**Submission of Further Information (FI)**

**Temporary Place of Recreation, Sports or Culture (Barbecue Area and Ancillary Kiddie Ride Area) and Holiday Camp (Private Tent Camping Ground) for a Period of 6 Years, Lots 788 (Part), 790 (Part), 793, 794 and 801 RP in D.D. 381 and Adjoining Government Land, Tuen Mun, New Territories**

We would like to submit further information to respond to the comments from the Drainage Services Department dated 13.8.2024 and Lands Department dated 19.8.2024.

Plan 5.1  
( P 22015 )

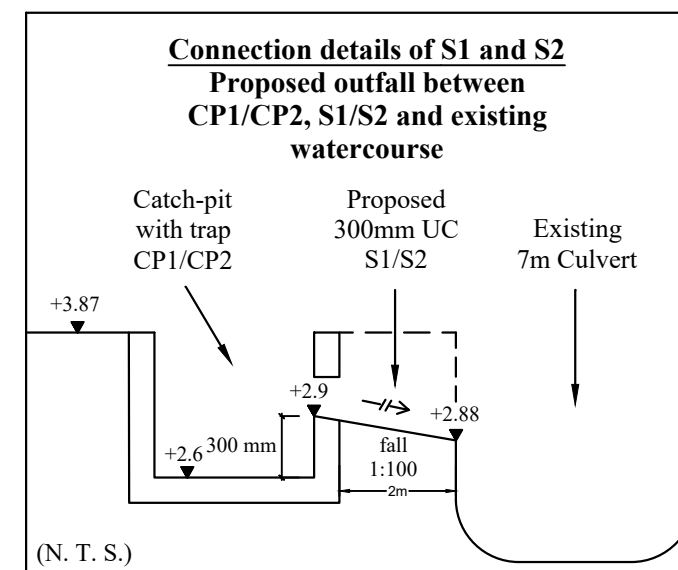
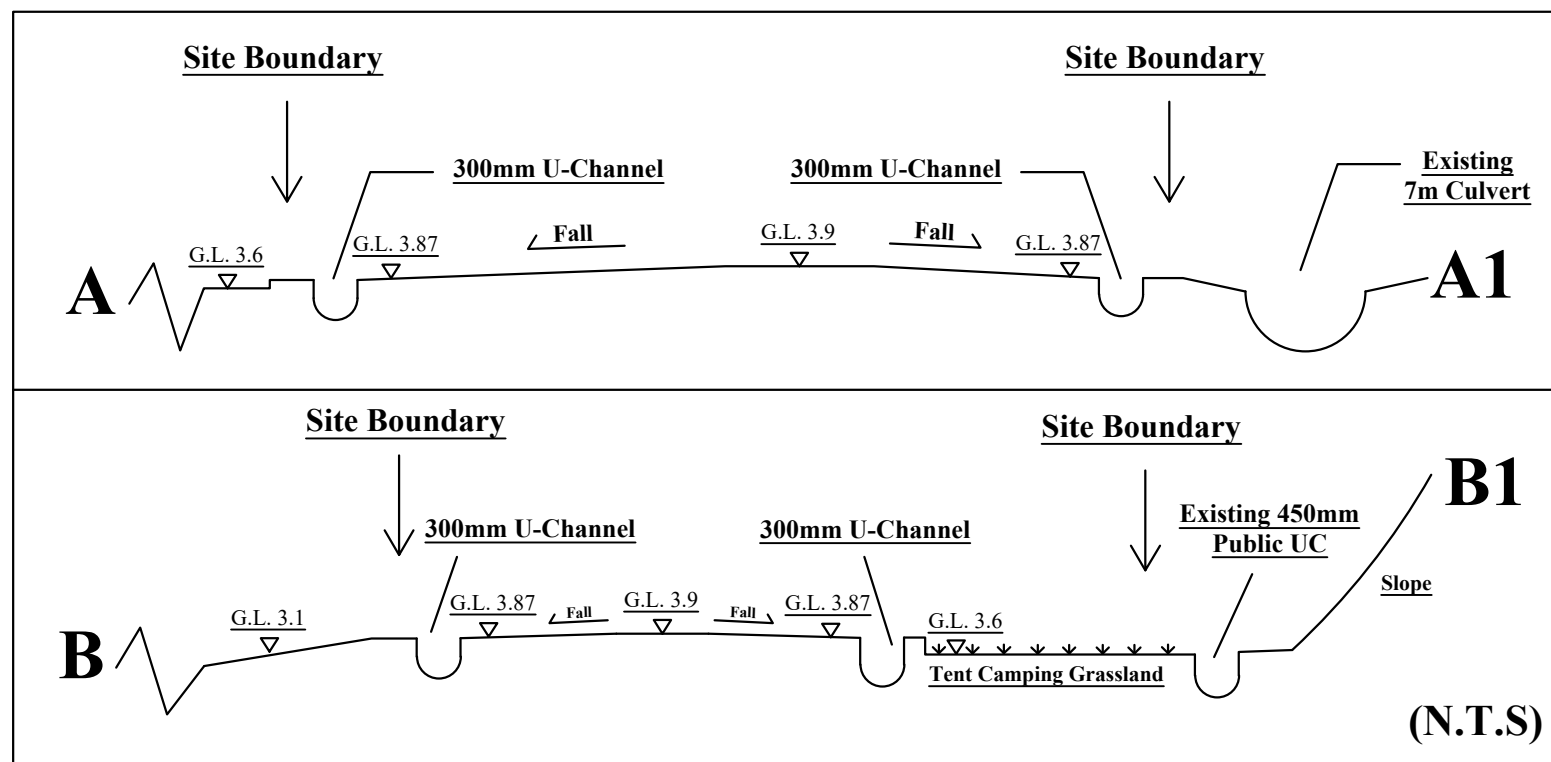
|    | Comments  | Responses   |
|----|---|---|
| a. | It appears that the stormwater drainage proposal for Lots 788 (Part) & 790 (Part) were missing from the submission. Please provide.   | The applicant undertakes to construct drainage facilities along the site boundary of lots 788 (Part) and 789 (Part) in D.D. 381. A revised drainage proposal will be submitted for approval after the planning application is approved. |

The applicant undertakes to construct drainage facilities along the site boundary of this area (Lots 788(part) and 789(part) in D.D. 381).  
A revised drainage proposal will be submitted for approval after the planning application is approved.

| <b>August 2024</b> | Lot No. 788(part), 790(part), 793, 794 & 801 RP in D. D. 381<br>and Adjoining Government Land<br>Tuen Mun, New Territories | <b>Plan 3b<br/>(P 22015)</b>                  |

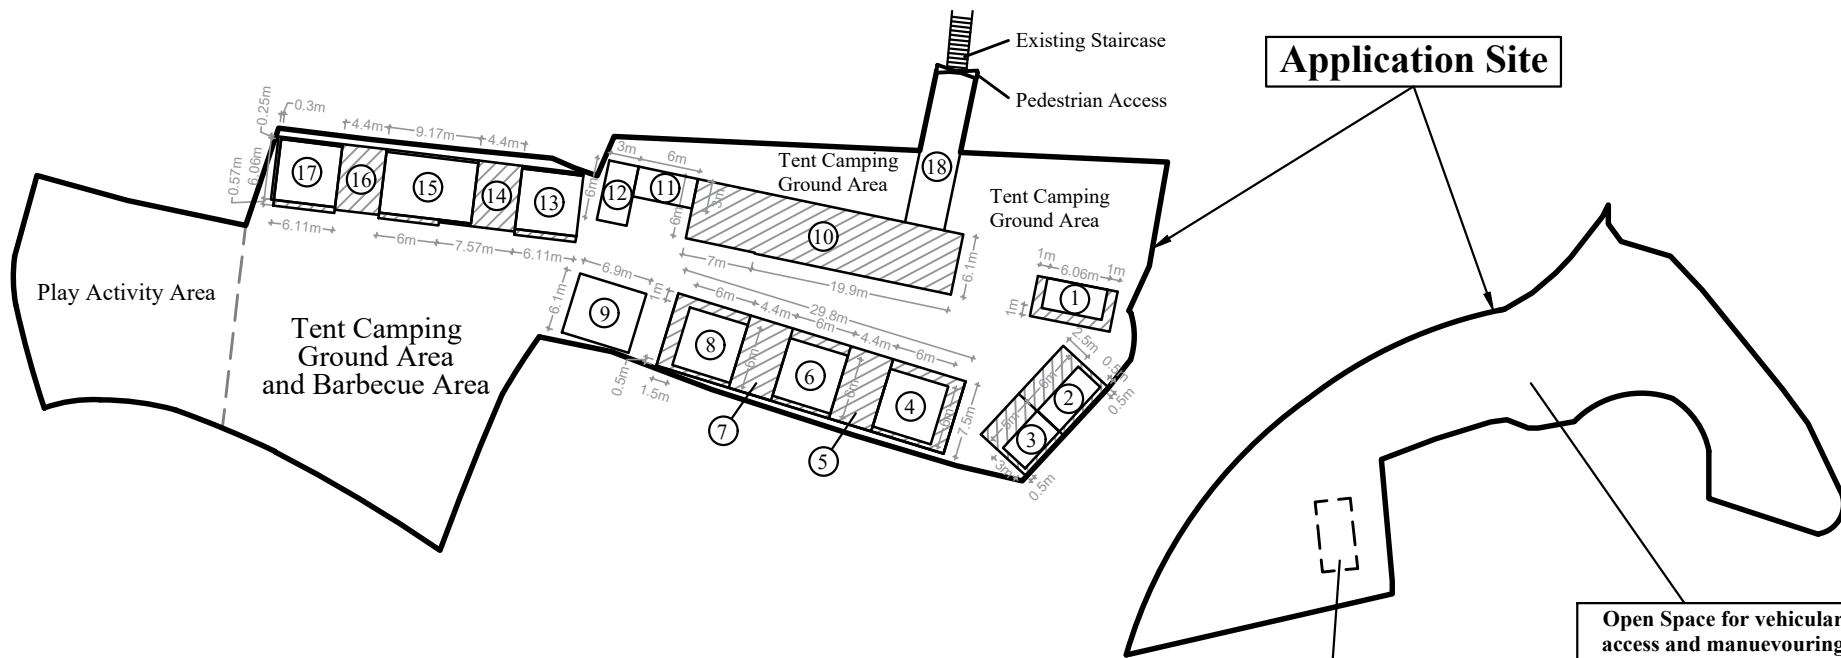
| Comments  | Responses  |                                       |  |                                       |   |         |                  |                  |                  |                  |                   |                      |  |   |                  |                           |                     |  |  |                            |  |
|---|--|---------------------------------------|--|---------------------------------------|---|---------|------------------|------------------|------------------|------------------|-------------------|----------------------|--|---|------------------|---------------------------|---------------------|--|--|----------------------------|--|
| <p>2. A site inspection conducted on 31.7.2024 revealed that all unauthorized tents and storeroom not covered by the subject application and miscellaneous items on Government land identified during the site inspections on 19.4.2024 and 27.6.2024 respectively had been removed. As regards an unauthorized porch not covered by the subject planning application and the discrepancy between the built-over area of the unauthorized structures covered by the subject application as shown on the layout plan provided by the applicant (i.e. structures nos. 2 to 9 as shown in Plan 3b (P 22015) dated July 2024) and our on-site measurement during previous site inspections vide para. 2 in our memo under ref. (84) in DLOTM 14/MAT/23 dated 6.5.2024 [note to applicant: please refer to para.2 of DLO/TM’s comments vide PlanD’s email dated 8.5.2024], the applicant is required to clarify the discrepancy and rectify the unauthorized porch not covered by the subject planning application (see attached plan).</p> <p><i>[See attachment "Plan A_TM_592 FI dd 26.7.2024.pdf"]</i></p> | <p>The layout plan is updated. Structure nos. 2 to 9 are updated to be the same as the current situation. Portion of the porch (northern side) of structures 4 to 8 has been removed The updates are as follows:</p>

<table><tr> <th>Structures no(s).</th> <th>BOA in Plan 3a (Previous plan)</th> <th>Measurement by applicant on 13.8.2024</th> <th>BOA in Plan 3b (Updated plan and current situation)</th> </tr><tr> <td>2 and 3</td> <td>58m<sup>2</sup></td> <td>72m<sup>2</sup></td> <td>72m<sup>2</sup></td> </tr><tr> <td>4, 5, 6, 7 and 8</td> <td>173m<sup>2</sup></td> <td>270.91m<sup>2</sup></td> <td>223.5m<sup>2</sup><br/>(after removal of portion of porch)</td> </tr><tr> <td>9</td> <td>60m<sup>2</sup></td> <td><u>42.09m<sup>2</sup></u></td> <td>42.09m<sup>2</sup></td> </tr></table>

<p>Note: BOA (Built-over area)</p> <p>Please refer to updated layout plan (<b>Plan 3b</b>) for details.</p> | Structures no(s).                     | BOA in Plan 3a (Previous plan)                             | Measurement by applicant on 13.8.2024 | BOA in Plan 3b (Updated plan and current situation) | 2 and 3 | 58m <sup>2</sup> | 72m <sup>2</sup> | 72m <sup>2</sup> | 4, 5, 6, 7 and 8 | 173m <sup>2</sup> | 270.91m <sup>2</sup> | 223.5m <sup>2</sup><br>(after removal of portion of porch) | 9 | 60m <sup>2</sup> | <u>42.09m<sup>2</sup></u> | 42.09m <sup>2</sup> |  |  | <u>313.00m<sup>2</sup></u> |  |
| Structures no(s).   | BOA in Plan 3a (Previous plan)   | Measurement by applicant on 13.8.2024 | BOA in Plan 3b (Updated plan and current situation)        |                                       |   |         |                  |                  |                  |                  |                   |                      |  |   |                  |                           |                     |  |  |                            |  |
| 2 and 3   | 58m <sup>2</sup>   | 72m <sup>2</sup>                      | 72m <sup>2</sup>   |                                       |   |         |                  |                  |                  |                  |                   |                      |  |   |                  |                           |                     |  |  |                            |  |
| 4, 5, 6, 7 and 8  | 173m <sup>2</sup>  | 270.91m <sup>2</sup>                  | 223.5m <sup>2</sup><br>(after removal of portion of porch) |                                       |   |         |                  |                  |                  |                  |                   |                      |  |   |                  |                           |                     |  |  |                            |  |
| 9   | 60m <sup>2</sup>   | <u>42.09m<sup>2</sup></u>             | 42.09m <sup>2</sup>  |                                       |   |         |                  |                  |                  |                  |                   |                      |  |   |                  |                           |                     |  |  |                            |  |
|   |  | <u>313.00m<sup>2</sup></u>            |  |                                       |   |         |                  |                  |                  |                  |                   |                      |  |   |                  |                           |                     |  |  |                            |  |
| <p>3. It is noted from the revised Form No. S16-1 attached to the FI that the proposed building height of each structure is revised to 6m from 4m while the proposed no. of storey remains at 1 storey, such proposed building height of 6m (about) for one- storey structure is considered excessive, please request the applicant to justify. You may also wish to note that from our recent on-site measurement, the building height of the existing structures covered by the subject planning application varies from 2.5m to 4.5m (approximate).</p>  | <p>The building height of the structures is updated. Please refer to updated layout plan (<b>Plan 3b</b>) for details.</p>   |                                       |  |                                       |   |         |                  |                  |                  |                  |                   |                      |  |   |                  |                           |                     |  |  |                            |  |
